DESIG	n of	DRAWN BY	DART AEROSPACE HAWKESBURY, ONTARIO, CAN	
CHEC	KED M	APPROVED #	DRAWING NO.	REV. A
	#	11	DSI 9349	SHEET 1 OF 1
DATE			TITLE	SCALE
06.0	06.08.16		RIVET CHANGE	NTS
Α		06.08.16	NEW ISSUE

## **DART SERVICE INSTRUCTION**

TO AMEND INSTALLATION INSTRUCTIONS IIN-D350-689 Rev.A
AND INSTRUCTIONS FOR CONTINUED AIRWORTHINESS ICA-D350-689 Rev.0
REF. CANADIAN STC: SH02-33
REF. FAA STC: SR01620NY

D350-689-041 Dual High Back Seat Assembly

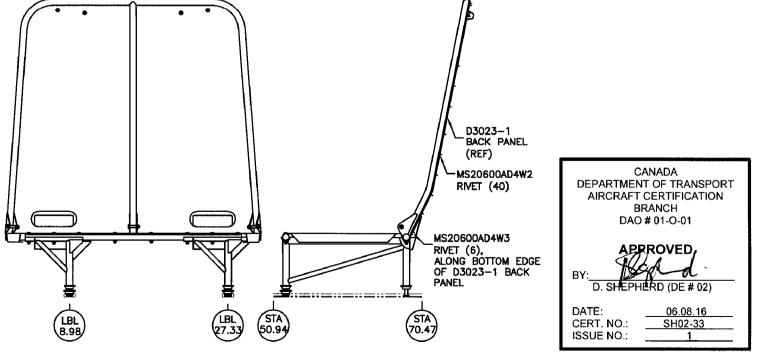
Some rivet lengths have changed, as indicated below, to ensure proper assembly of the D350-689-041 Dual High Back Seat Assembly. If installing replacement parts, it is acceptable to use longer rivets in other locations as required to ensure proper fastening. The parts list is revised as follows:

## WAS:

QTY -041	Part Number	Description
Х	D350-689-041	DUAL HIGH BACK SEAT ASSEMBLY
46	MS20600AD4W2	RIVET

## NOW:

QTY -041	Part Number	Description
Х	D350-689-041	DUAL HIGH BACK SEAT ASSEMBLY
40	MS20600AD4W2	RIVET
6	MS20600AD4W3	RIVET
